Access Compliance Report

Public Rights-of-Way

Intersection ID: 17207	Main Street: CHILTON_PL	Cross Street: QUEENS_RD_EAST	Location: S
ADA ID: F978B7E9BD2F	Ramp Type: Directional1	Initial Pass/Fail: Fail	Overall Compliance: No
		Severity Score: 12.5

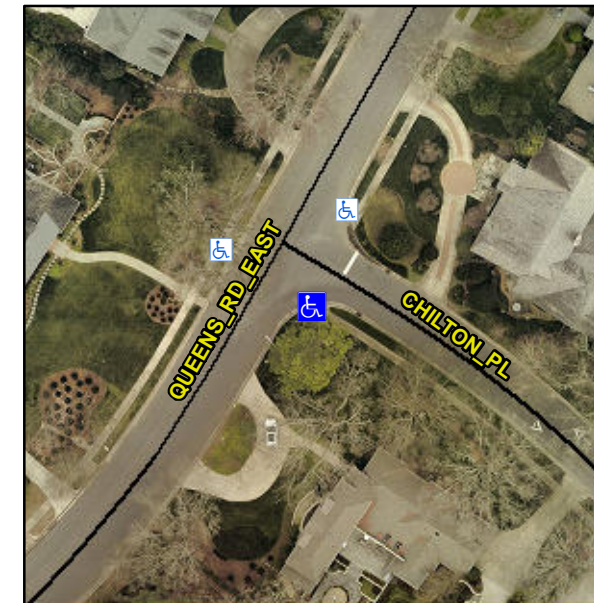
R304.2.2

Compliance	Description	Data	Compliance	Description	Data
N/A	Ramp Length (in)	57.5	N/A	Grade Break?	N/A
Yes	Ramp Width (in)	53.0	N/A	Grade Break Slope (%)	0.0
No	Ramp Slope (%)	8.7	N/A	Grade Break XSlope (%)	0.0
Yes	Ramp XSlope (%)	1.5			
N/A	Flare Type LT	N/A	N/A	Flare Type RT	N/A
N/A	Flare Slope LT (%)	N/A	N/A	Flare Slope RT (%)	0.0
N/A	Flare Traversable LT?	N/A	N/A	Flare Traversable RT?	N/A
N/A	Landing Length (in)	0.0	N/A	DWS Provided?	N/A
N/A	Landing Width (in)	0.0	N/A	DWS Contrast?	N/A
N/A	Landing Slope (%)	0.0	N/A	DWS Length (in)	N/A
N/A	Landing X Slope (%)	0.0	N/A	DWS Full Width?	N/A
N/A	Landing Curb? (Y/N)	N/A	N/A	DWS Offset LT (in)	N/A
N/A	Shared Landing?	N/A	N/A	DWS Offset RT (in)	N/A
N/A	Gutter Ponding?	0.0	N/A	Gutter Slope (%)	N/A
N/A	Gutter Lip Ht (in)	0.0	N/A	Gutter X Slope (%)	N/A
N/A	Painted X Walk1?	No		Road Slope (%)	1.7
	X Walk 1 Direction	To W		Road X Slope (%)	7.4
	X Walk 1 Width (in)	N/A		Clear Space?	N/A

Remove & Replace Entire Ramp.
